APPENDIX V: TLG TRANSPORTATION STUDY

Office	TLG Transport Inc 4328 CO-66 Longmont, CO 80504 (303) 678-8384 (303) 678-8714 www.tlgtransport.com	Status	For information
		Doc No	
		Date	April 2020
		Issued to	
Issued by	TLG Transport	Client	GE
Project	Horse Heaven, Pasco WA	Job No

Subject Preliminary site review (This study is for feasibility only and not to be used for permitting purposes without a physical survey being conducted by the carrier)

Horse Heaven Wind Project (Summary)

I-82 South exit number 122 Coffin Road East (If needed)

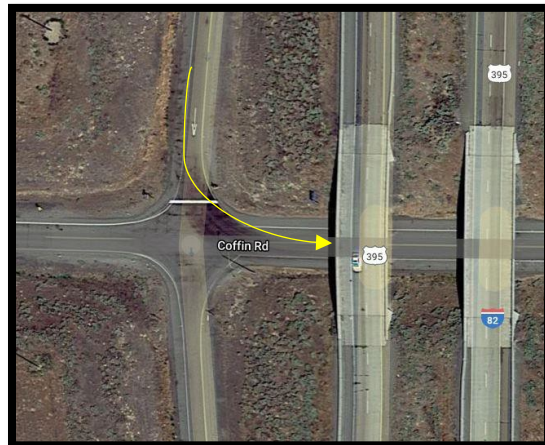
- Signs will need to be modified to removable (currently wood).
- Radius improvements to GE specifications will be needed.
- Cut slopes inside turn and rear sweep (TBD by civil engineering designs within GE specifications).

At Beck Road

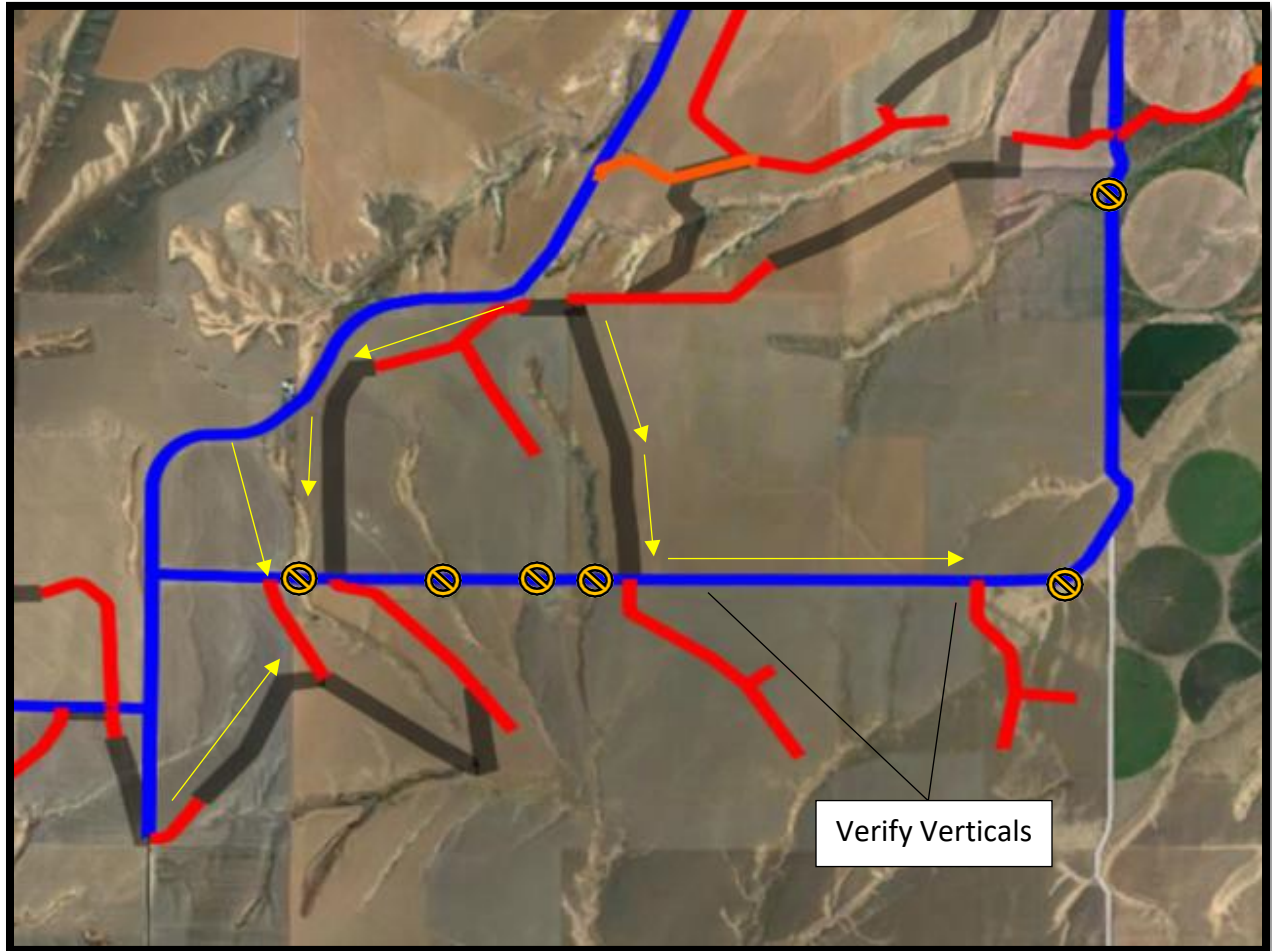
- Turn cannot be completed as constructed plus incline after turn.
- Customer proposes to crossover from Nine Canyon Road to Beck Road to bypass these obstacles.
- Verify verticals out about 0.8 to 0.9 miles to last string off Beck.

Example of acute decline and inclines on Kirk

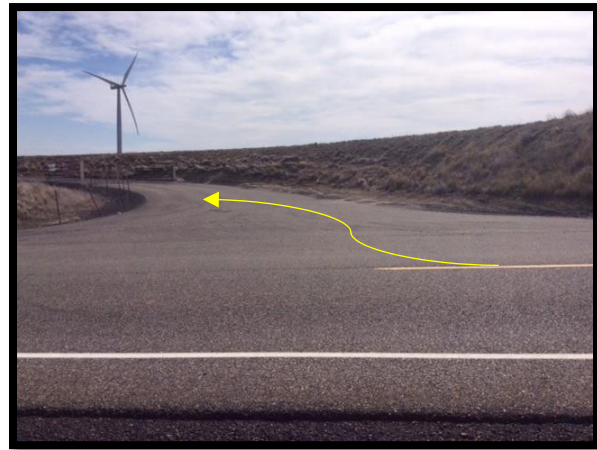
- The right turn to Kirk Road can be improved however this road has deep declines with acute inclines (See example below).
- Two vertical deviations in the first 0.3 miles before first string South.
- Recommendation is for customer to consider building new strings along knolls to avoid substantial civil improvements to Kirk Road from Nine Canyon for Western site South of Kirk or from Miles and Nine Canyon existing proposed access point for other strings.
- About 1.8 miles East of Nine Canyon Road on Kirk tie in from Miles string **verify vertical deviations meet GE specification or improve as needed.**

Access to Finley from Nine Canyon at Miles

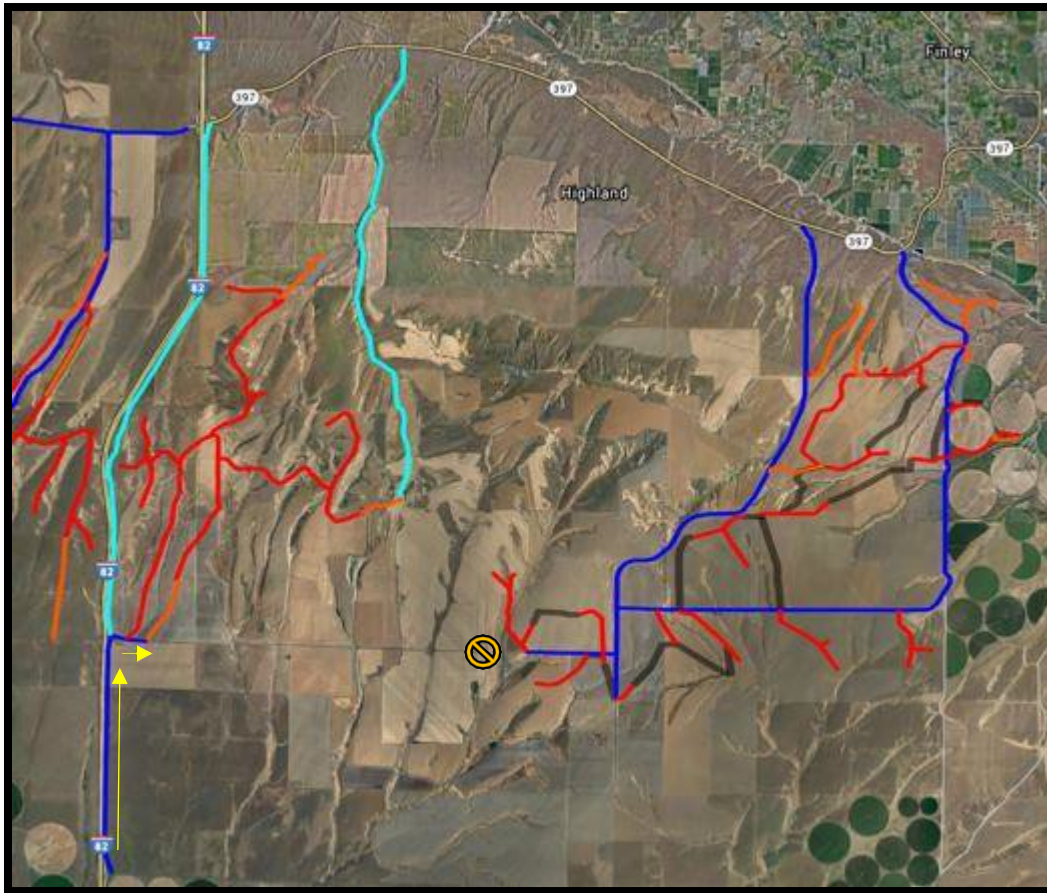
- Finley cannot be access from Kirk or 397 without significant civil improvements (grades curves etc.).
- Coming from 374 would not line up access to Northeast most string.
- Creating path from Nine Canyon at Miles with extensions of proposed strings is recommend if customer want to access the proposed sites off Finley.
- (Stop – Return to Coffin and Bofer Canyon Road).

Coffin left turn to Bofer Canyon Road

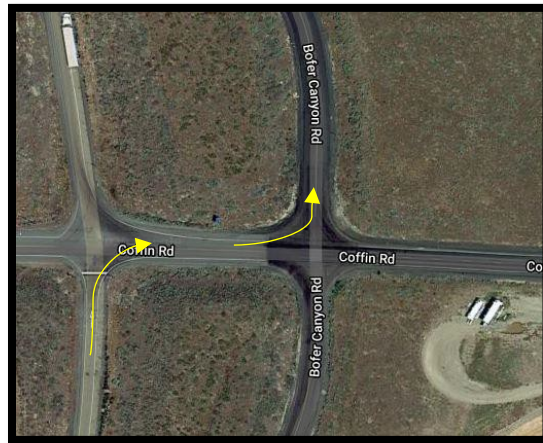
- Signs will need to be modified to removable.
- Radius improvements to GE specifications will be needed.
- Cut slopes inside turn and rear sweep (TBD by civil engineering designs within GE specifications).

Boyer Canyon Road to Beck

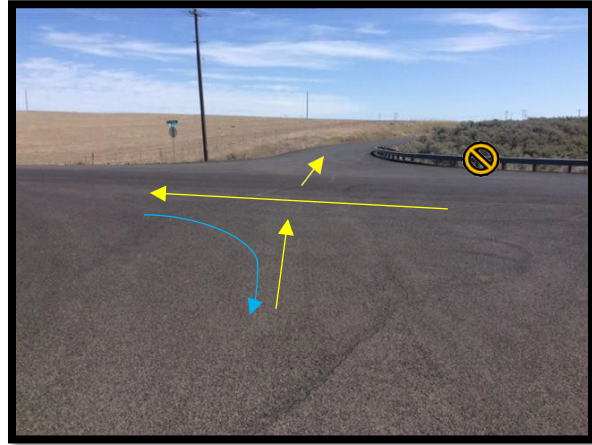
- Signs will need to be modified to removable.
- Radius improvements to GE specifications will be needed in NW corner.
- NE and SE corner has guard rail and deep ditches.
- 3 point turn will need to be approved by GE and their carriers.

At Niconson

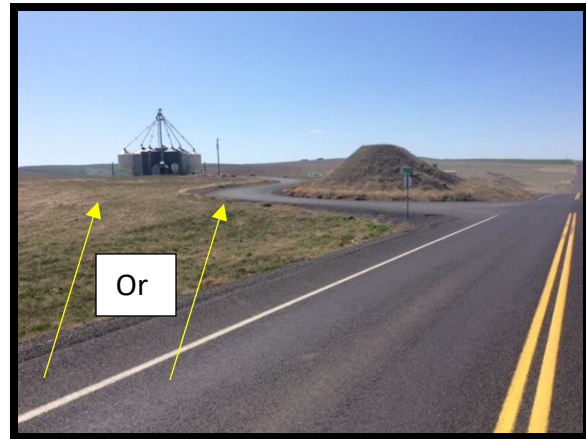
- Signs will need to be modified to removable.
- Radius improvements to GE specifications will be needed.
- Will need use of outside radius to avoid power pole in rear sweep.

At H Smith 8.7 miles West of I-82 Interchange (reviewed for 0.4 miles)

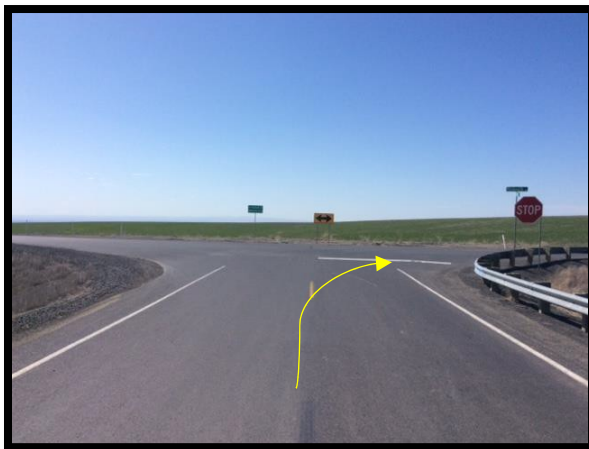
- Improve turn to GE specifications as necessary to accommodate all components for selected platform.
- 0.2 miles vertical deviation (customer plan?)
